Access Compliance Report

Public Rights-of-Way

Intersection ID: 45511	Main Street: MEADOW_BOTTOM_RD	Cross Street: GINHOUSE_LN	Location:	W
ADA ID: 3A21779B409F	Ramp Type: PerpDiag	Initial Pass/Fail: Fail	Overall Compliance: No	Severity Score: 22.5
Codes/Mitigation Info/Possible Solution		Field Measurements/Component Compliance

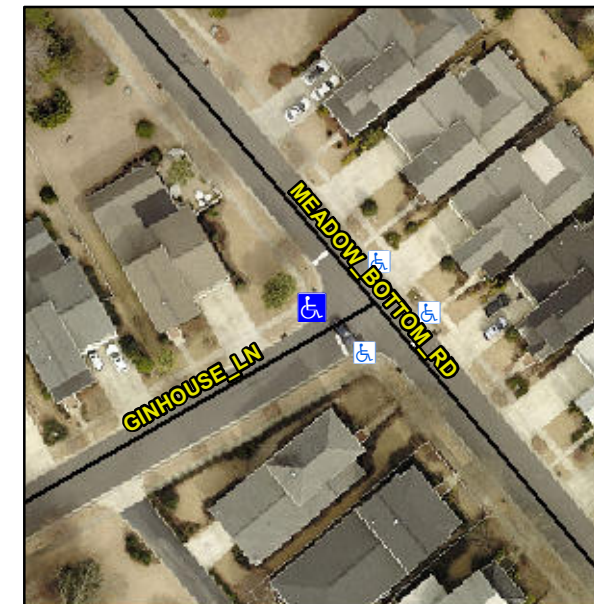
R304.5.1, R304.2.2, R304.5.3

Compliance	Description	Data	Compliance	Description	Data
N/A	Ramp Length (in)	73.0	No	Ramp Slope (%)	9.6
No	Ramp Width (in)	46.0	No	Ramp XSlope (%)	2.3
N/A	Flare Type LT	N/A	N/A	Flare Type RT	N/A
N/A	Flare Slope LT (%)	N/A	N/A	Flare Slope RT (%)	N/A
N/A	Flare Traversable LT?	N/A	N/A	Flare Traversable RT?	N/A
N/A	Landing Length (in)	N/A	N/A	DWS Provided?	N/A
N/A	Landing Width (in)	N/A	N/A	DWS Contrast?	N/A
N/A	Landing Slope (%)	N/A	N/A	DWS Length (in)	N/A
N/A	Landing X Slope (%)	N/A	N/A	DWS Full Width?	N/A
N/A	Landing Curb? (Y/N)	N/A	N/A	DWS Offset (in)	N/A
N/A	Shared Landing?	N/A			
N/A	Gutter Ponding?	N/A	N/A	Gutter Slope (%)	N/A
N/A	Gutter Lip Ht (in)	N/A	N/A	Gutter X Slope (%)	N/A
N/A	Painted X Walk1?	No	N/A	Painted X Walk2?	No
	X Walk 1 Direction	To SE		X Walk 2 Direction	To NE
N/A	X Walk 1 Width (in)	N/A	N/A	X Walk 2 Width (in)	N/A
	X Walk 1 Slope (%)	0.0		X Walk 2 Slope (%)	2.8
	X Walk 1 X Slope (%)	2.2		X Walk 2 X Slope (%)	2.3

Remove & Replace Curb Ramp With Two New Directional Ramps or Equivalent.
